# LANCASTER COUNTY PLANNING COMMISSION

# PLANNING STAFF REPORT: SD-015-005, TREE TOPS

**Proposal:** Preliminary Subdivision Plan Application of Lennar Carolinas, LLC

**Property Location:** The property is located at 9070 Van Wyck Road and consists of 613.613 acres.

**Preserve at Tree Tops** **Variance Exhibit – Culdesac Length**

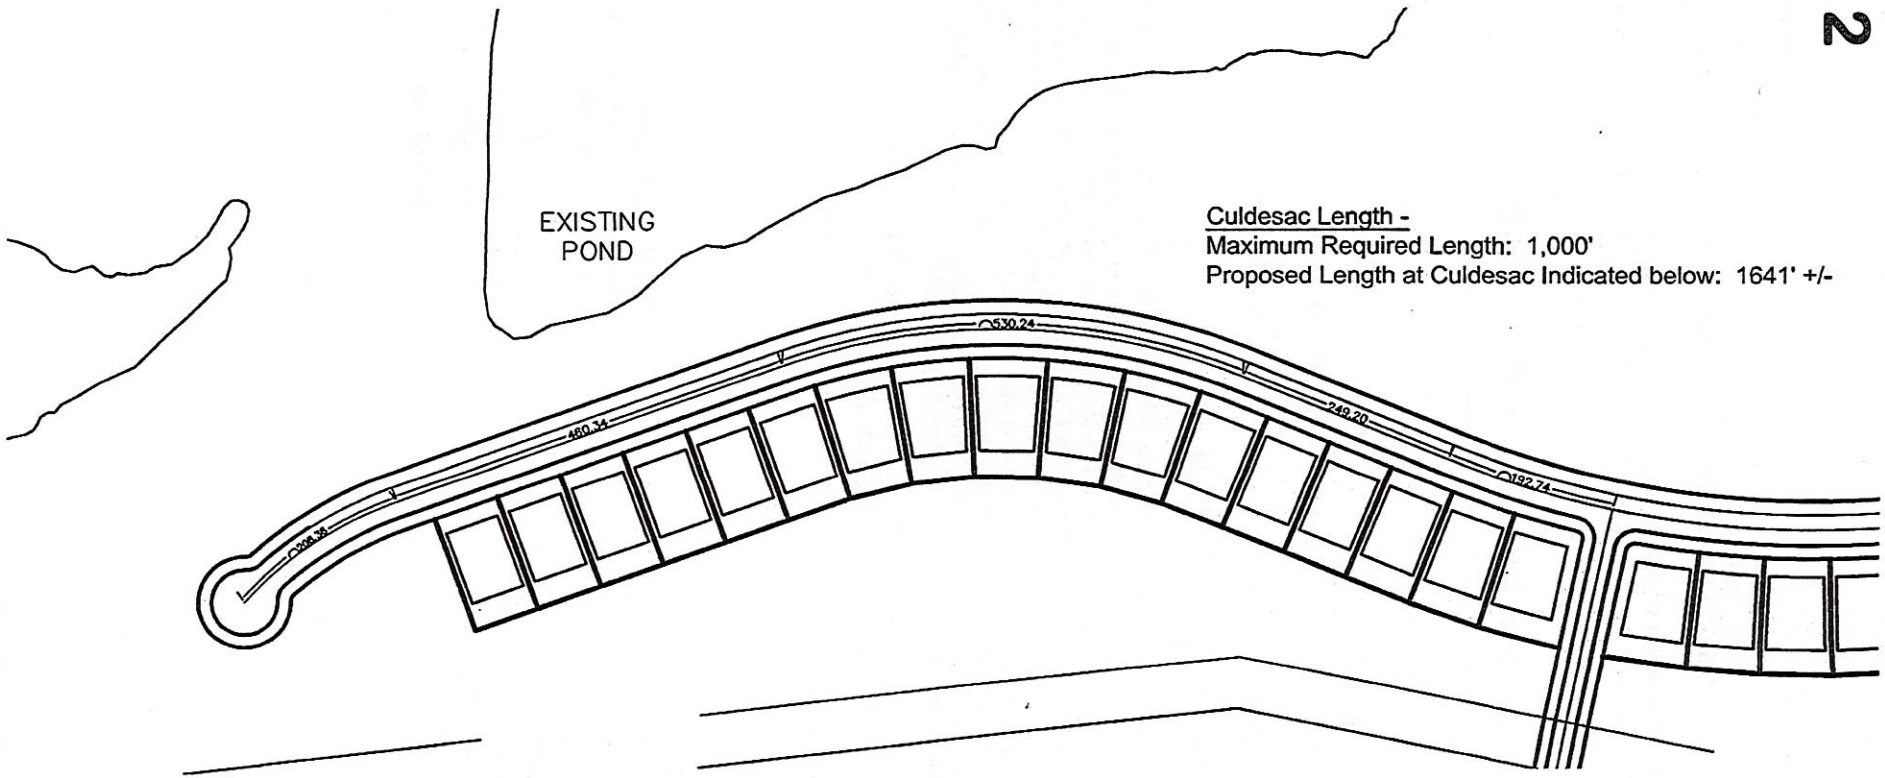
1. A request for a variance from the Lancaster County Code requirement for the maximum cul-de-sac length of 1,000 feet. The applicant has proposed a cul-de-sac not to exceed a length of 1,750 feet. This is a portion of Acadia Falls Drive which is perpendicular to Tranquility Blvd. See Exhibit 2.

- **Staff recommendation:** The applicant's design team states that the additional cul-de-sac length is necessary in order to provide access to a proposed lift station as well as future site amenities. Additionally they state that this cul-de-sac will allow for preservation of environmental features. Preservation of significant site features is a fundamental goal of the CSOD ordinance. Planning Staff recommends that this variance request be **APPROVED.**

Per Chapter 26 of the Lancaster County Code, "cul-de-sacs shall not exceed one thousand (1,000) feet in length, except where unusual topographic or other physical conditions dictate otherwise". A variance for the maximum 1,000 foot length is requested for one of the two proposed cul-de-sacs for the proposed Preserve at Tree Tops development. The proposed length is not to exceed 1,750 feet. This cul-de-sac is extended beyond the limits of the proposed single family lots to provide access to a proposed list station and other future site amenities. A cul-de-sac is used to avoid the unnecessary crossing of a jurisdictional stream channel. An exhibit is attached indicating the location of this cul-de-sac.

Preserve at Tree Tops — Variance Exhibit – Park Block Length

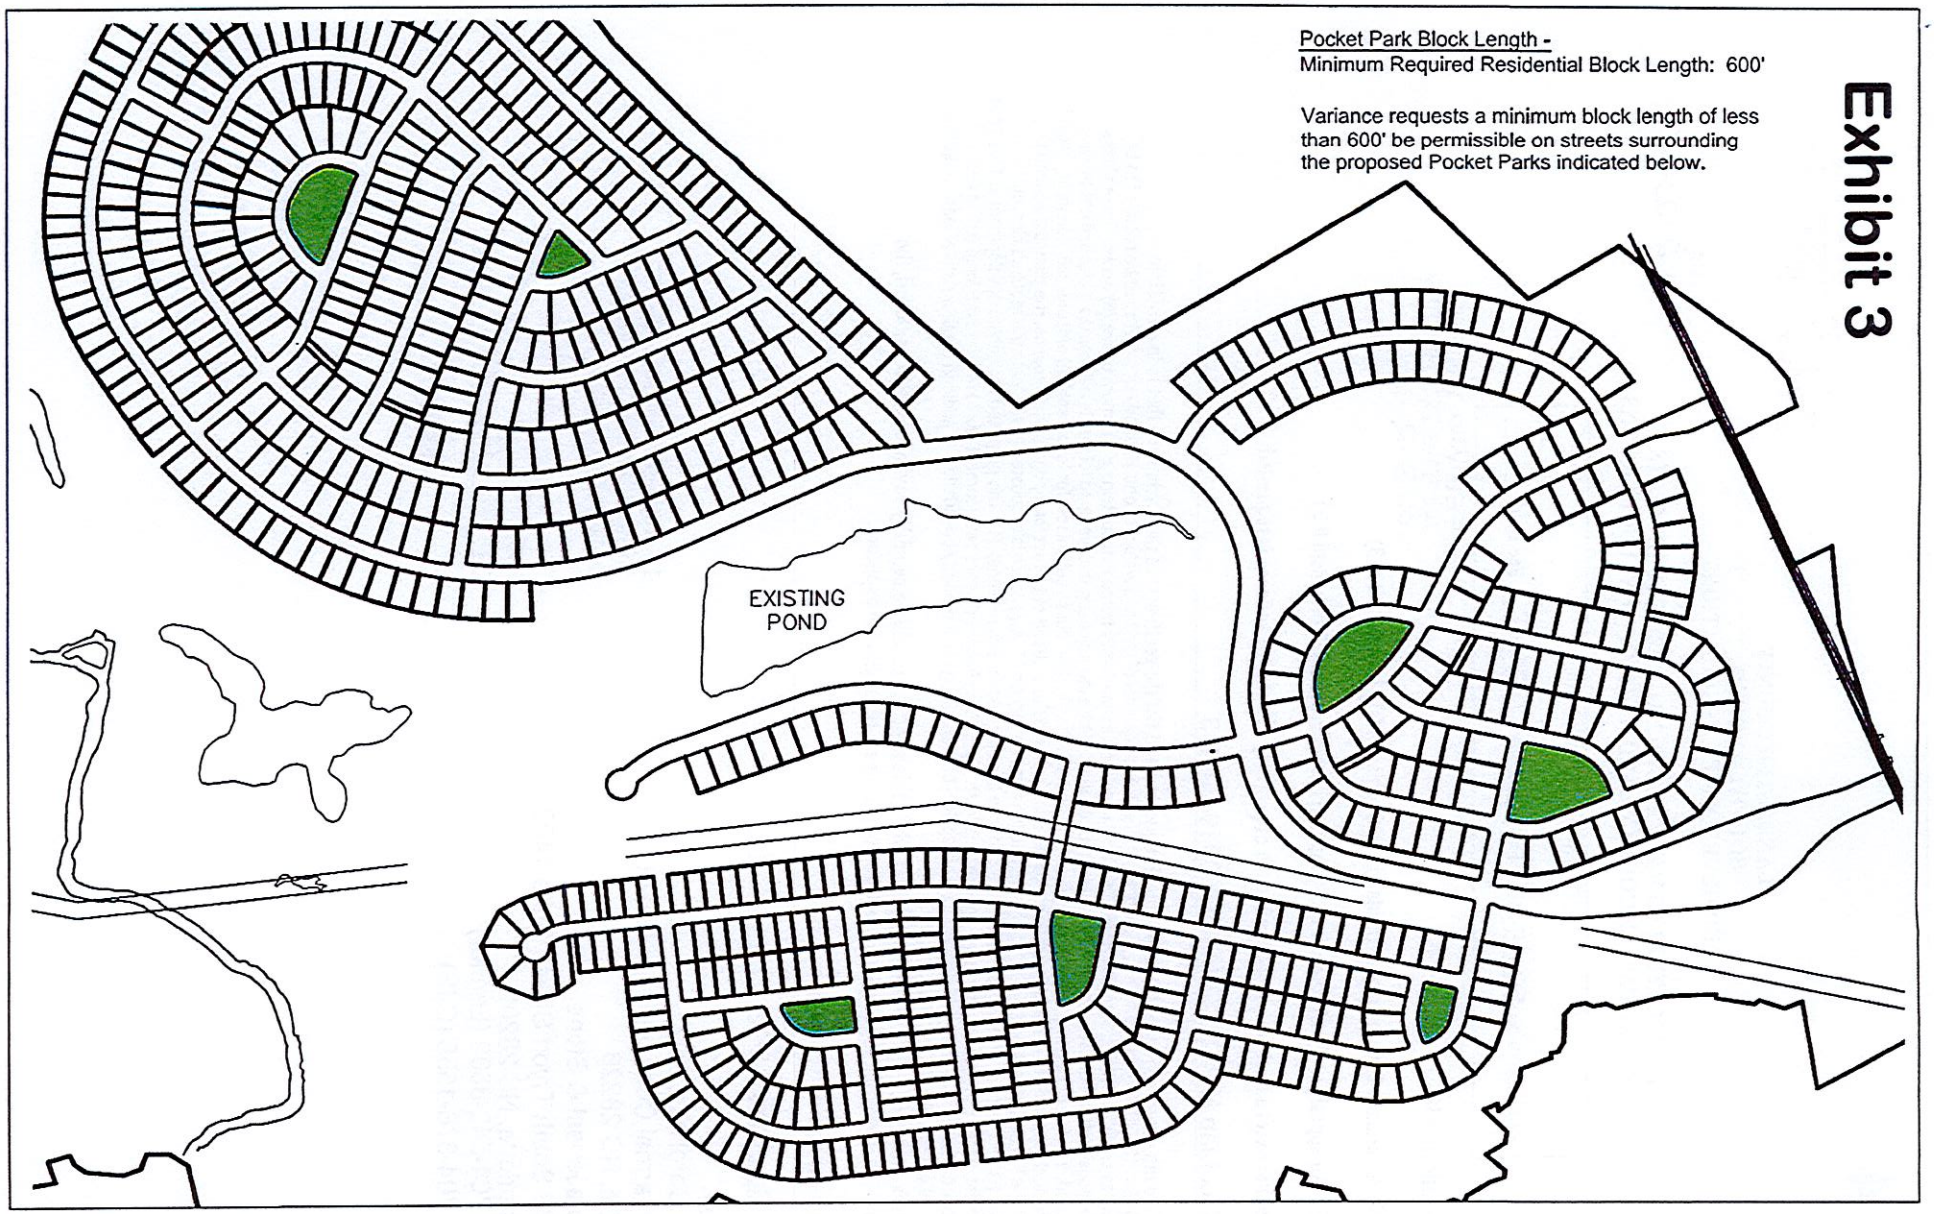
2. A request for a variance from the Lancaster County UDO standard which requires a minimum block length of 600'. See Exhibit 3.

- **Staff recommendation:** The applicant's design team states that this variance request will allow for block lengths of less than 600 feet around the perimeter of pocket parks within Tree Tops. It is Staff's opinion that such pocket parks within Tree Tops can provide recreational, social and aesthetic benefits within Tree Tops. Planning Staff recommends that this variance request be **APPROVED.**

Per Section 13.7.9.1 of the Lancaster County UDO, the "the length of blocks hereafter established should not exceed one thousand eight hundred (1,800) feet and shall not be less than six hundred (600) feet". This section also states "the length of blocks may be modified, when appropriate, due to the topography or physical shape of the property being subdivided". Within the proposed Preserve at Tree Tops development several pocket parks have been incorporated. Due to the site's topography and physical shape, these parks represent area that would otherwise be dedicated to open space. In all cases, these parks have been located in a manner so they are surrounded by lots on all sides in order to increase access by residents. A variance is requested to allow block lengths less than 600 feet around the perimeter of pocket parks. Attached is an exhibit locating proposed pocket parks where a shorter residential block length will be utilized.

Pocket Park Block Length -
Minimum Required Residential Block Length: 600'

Variance requests a minimum block length of less than 600' be permissible on streets surrounding the proposed Pocket Parks indicated below.

Tree Tops — Variance Exhibit – Collector Street Sidewalks

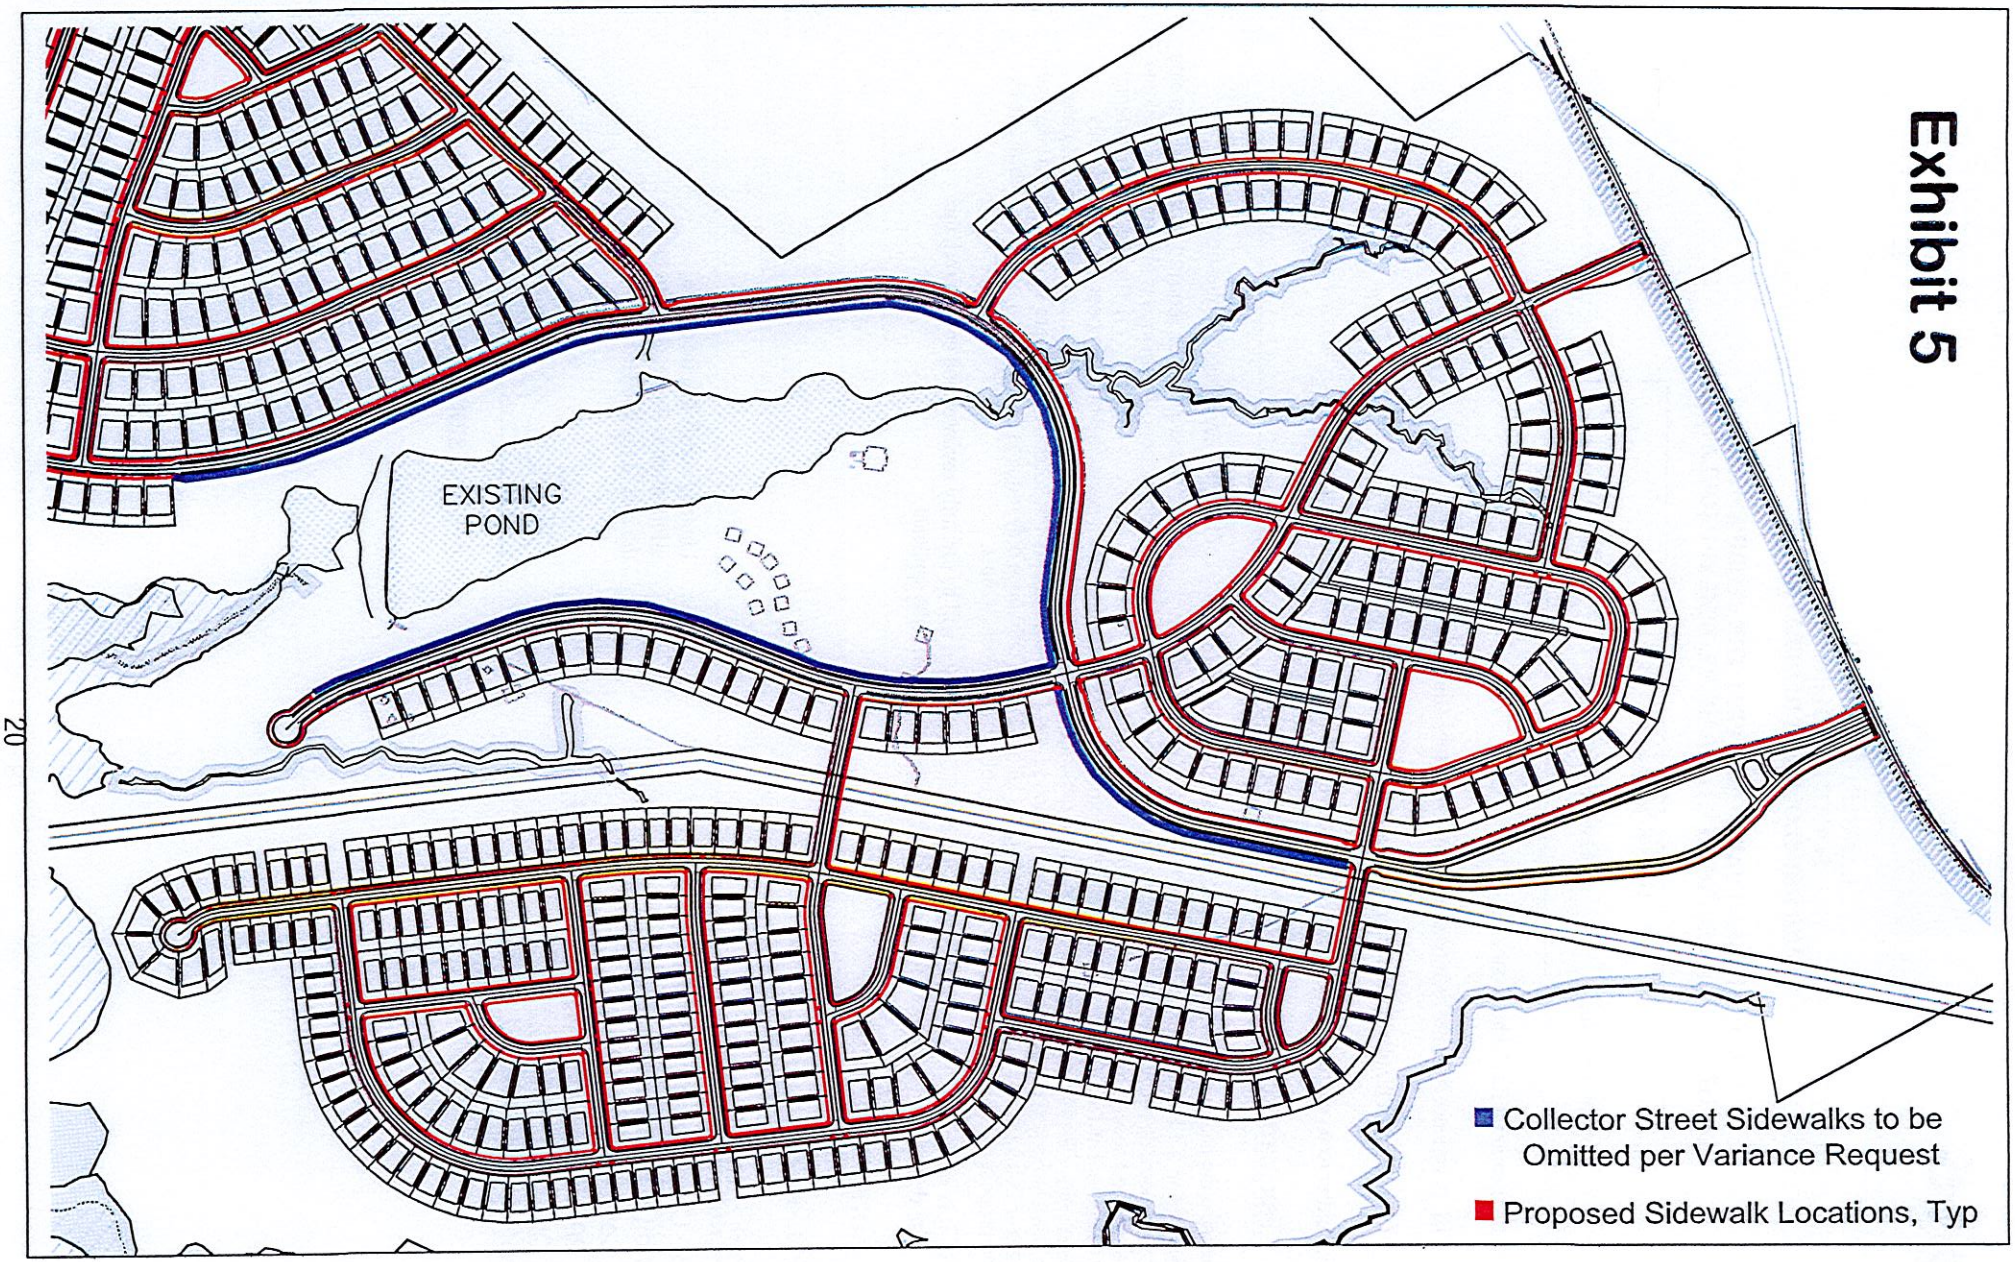
4. A request for a variance from the Lancaster County UDO standard which requires sidewalks on both sides of collector streets within Cluster Subdivisions. The streets in question include portions of Tranquility Boulevard and Acadia Falls Lane. See Exhibit 5.

- **Staff recommendation:** The applicant's design team states that this variance is requested due to (1) the nature of the applicable street cross-section as customized to this community. (2) The collector streets are principally located adjacent to the existing lake where walking trails will be provided. (3) The project already proposes sidewalks on both sides of the local streets which exceeds the minimum requirements of the Cluster Ordinance. Planning Staff recommends that this variance be **APPROVED.**

EMERGENCY ACCESS - OPTION 'A'

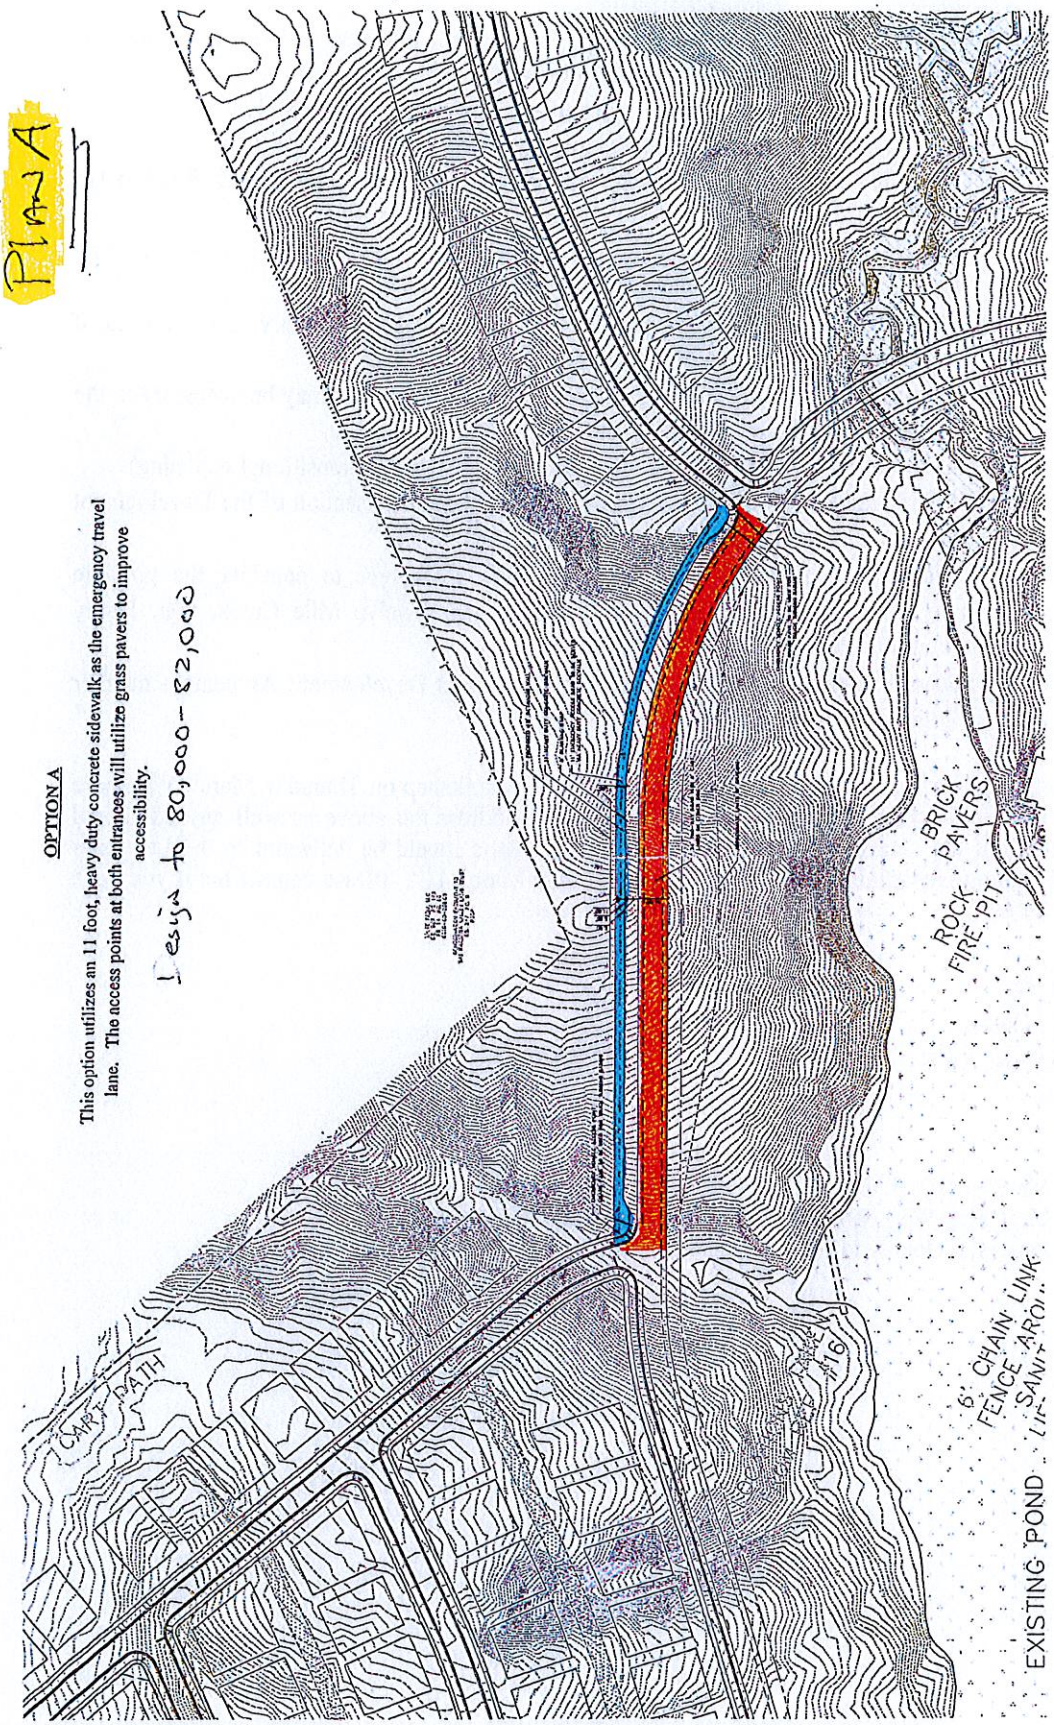
9) Conversely, public safety issues should always be addressed. The Lancaster County Fire Marshal raised a concern that warranted further review. To this end, Lennar Carolinas, LLC has proposed an alternative means of accessing the southernmost portion of the subdivision which has been of concern. Please note Sheet C-009 and Sheet C-013 within the Preliminary Plan resubmittal of March 11th, 2015. Additionally, please reference Exhibit 8, aka "Plan A". This plan has

This option utilizes an 11 foot, heavy duty concrete sidewalk as the emergency travel lane. The access points at both entrances will utilize grass pavers to improve accessibility.

Design to 80,000 - 82,000

parallel with the originally proposed Treetops Blvd. The Plan A was an 11 feet wide sidewalk capable of supporting up to 80,000 pound loads (largest fire truck weight). This sidewalk would be converted to an emergency access if ever needed due to any issues with the main road. The Plan B was similar, but made Tree Tops Blvd a divided lane with a section that was 45 feet wide near the intersections. Our concern with this plan(B) was that it has potential to cause traffic issues during normal use because the pavement was so wide at Samao Ridge Drive.

So we preferred Plan A as outlined above. While not an ideal solution, this Plan A alleviates our concerns regarding a secondary means of egress if the main road was temporarily impassable or otherwise blocked.
